CLEVELAND NATIONAL FOREST POWER LINE REPLACEMENT PROJECTS

MINOR PROJECT REFINEMENT REQUEST FORM

**Cleveland National Forest Power Line Replacement Projects
Minor Project Refinement Request #13
Attachment B: Photographs**

Attachment C: Survey Area Map
C442 Map 1 of 1

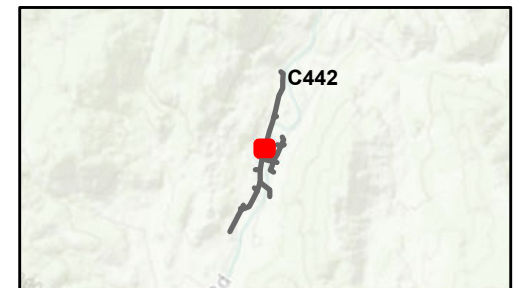
SDG&E is requesting to shift Pole P178040 to provide offset from the existing temporary access road.				
Date refinement is expected to be implemented:		02-15-18		
Resource Agency Coordination				
Resource Agency	Name	Action Required	Date	Documentation (see attached if yes)
Not Applicable (N/A)	N/A	N/A	N/A	<input type="checkbox"/> Yes <input type="checkbox"/> No

No Cultural Resources Occur within 50 feet of Requested Work Area
